# WAGGA WAGGA BASE HOSPITAL REDEVELOPMENT (SSD5237-2012)

## RESPONSE TO SUBMISSIONS

Project Status	Post-Exhibition	01	Revised as per comments received from HI and Consultants	12.07.2013	
	EIS Director	AL	02	Revised as per comments recieved from HI	17.07.2013	
	Checked by	AL	03	Final Report	18.07.2013	
	Date Issued	18 July 2013				
	Issue Type	For Minister's Determination				
	Proponent

FIGURE 01: Wayfinding Strategy - Public and visitor access

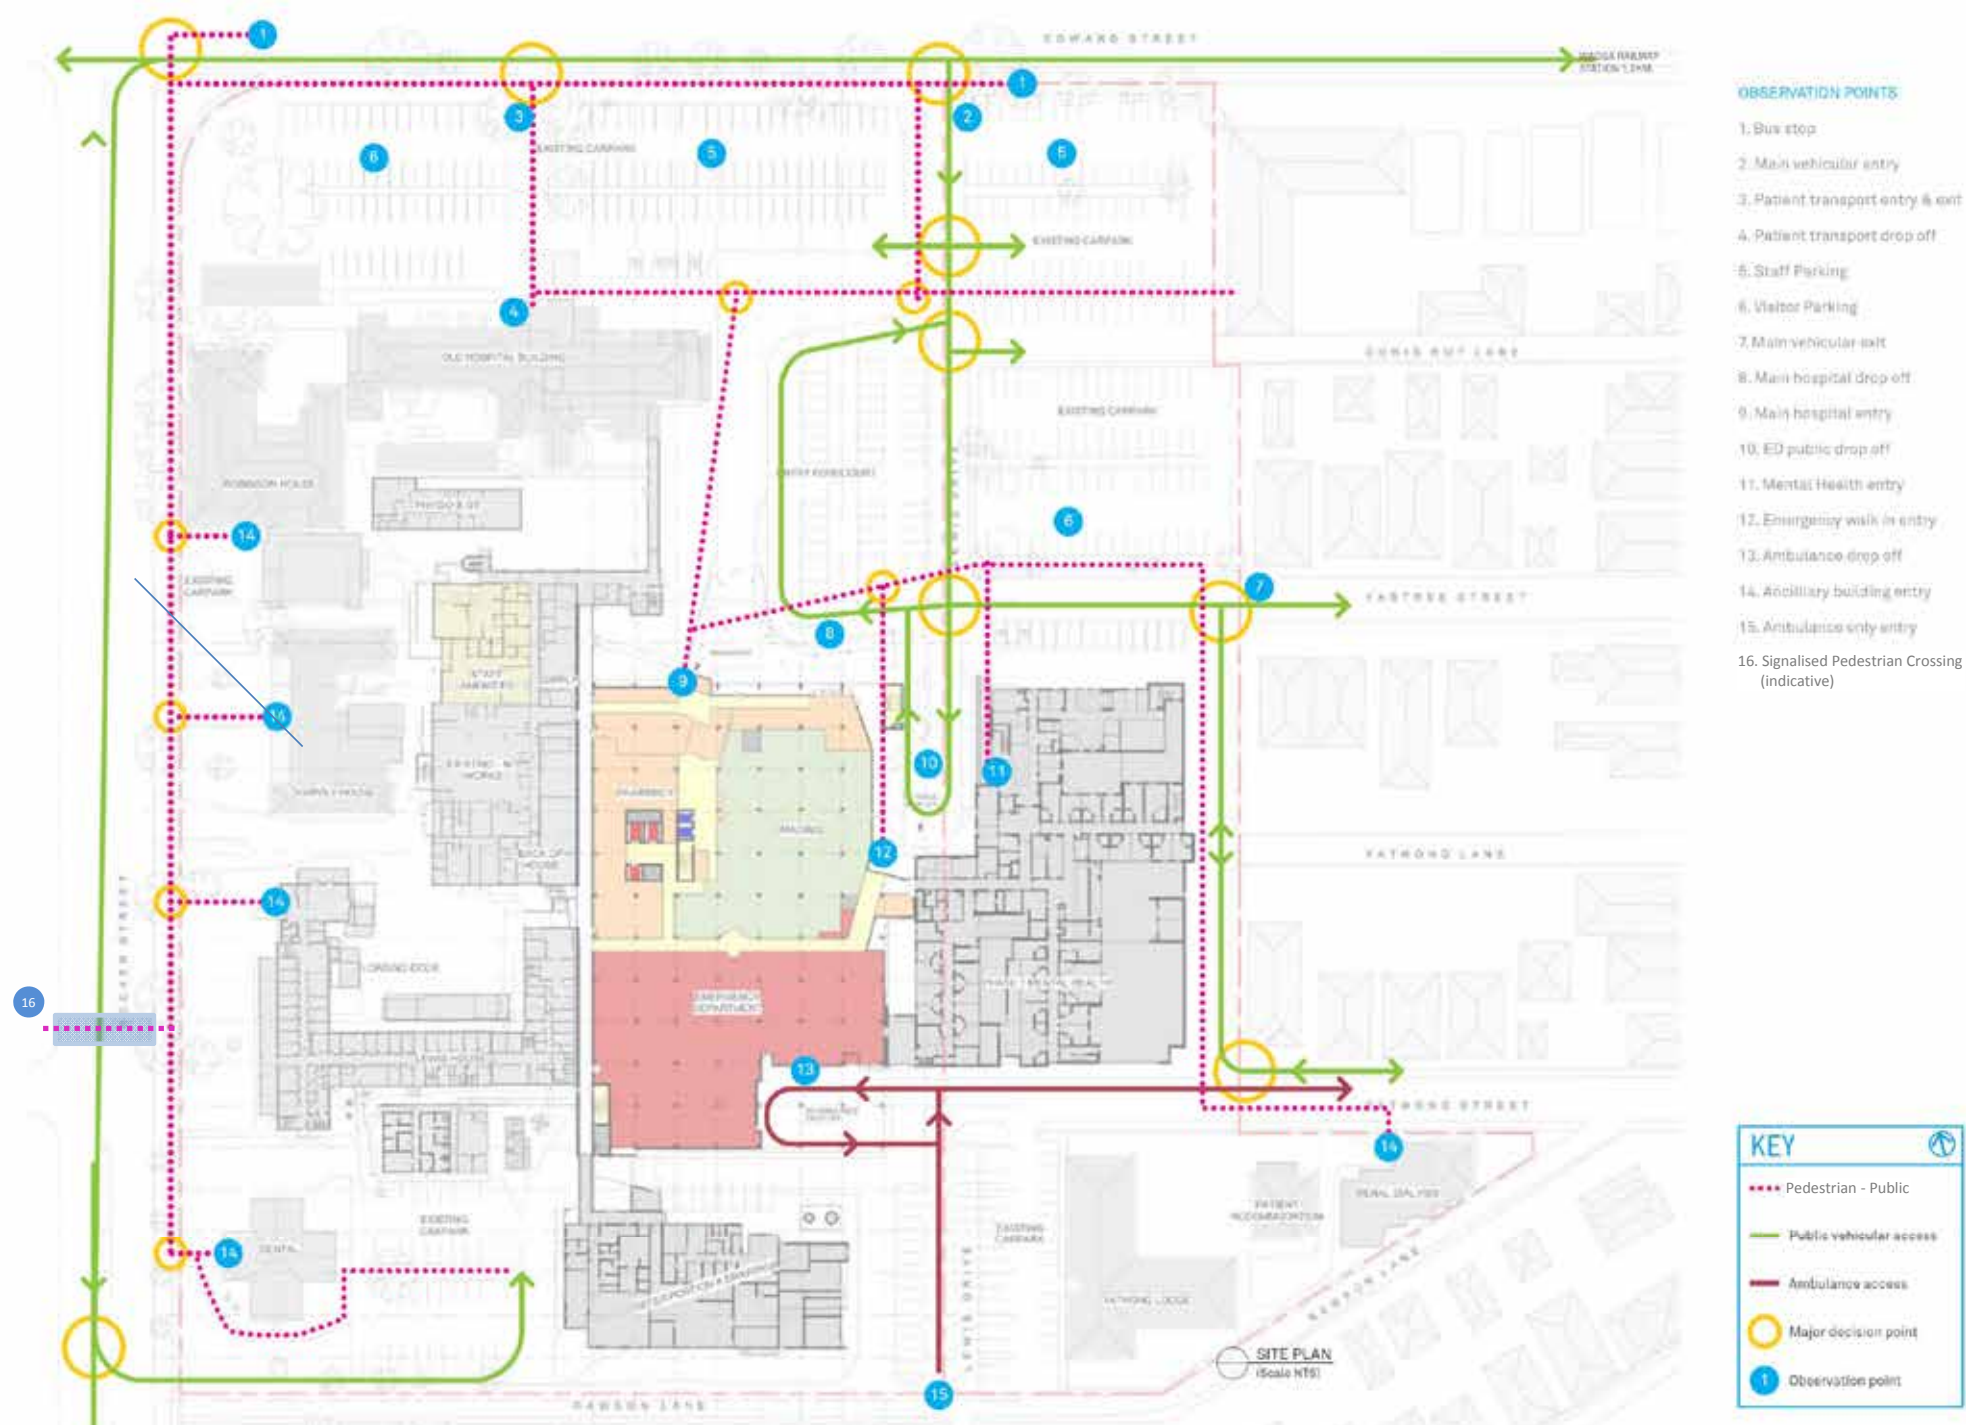
ISSUES / COMMENTS	RESPONSE
<p>RMS-02 <b><i>“As raised in previous submissions to the redevelopment of the Wagga Wagga Base Hospital site both the Wagga Wagga City Council and RMS favoured the construction of the internal roadway linking Yathong Street to Docker Street with appropriate intersection treatment as this option benefitted the hospital development and the encompassing health care precinct in terms of vehicular and pedestrian access and circulation. The benefits of this internal road option and intersection treatment were outlined in previous submissions to phase 1 and the concept plan.</i>”</b></p>	<p>It is noted that the Phase 1 Project Application did not include a proposal for the extension of Yathong Street to Docker Street.</p> <p>It is arguable that a roadway link between the Yathong Street and Docker Street would effectively bisect the site and introduce potential vehicle conflicts within the Hospital site.</p> <p>The installation of a signalised crossing on Docker Street to facilitate pedestrian and cycle links to Calvary Hospital will be provided as part of the Phases 2 and 3 redevelopment. This pedestrian crossing will be designed to have no impact on the existing Docker and Edward Street intersection. Refer to Figures 1 and 2, which provide an indicative location for the crossing.</p>
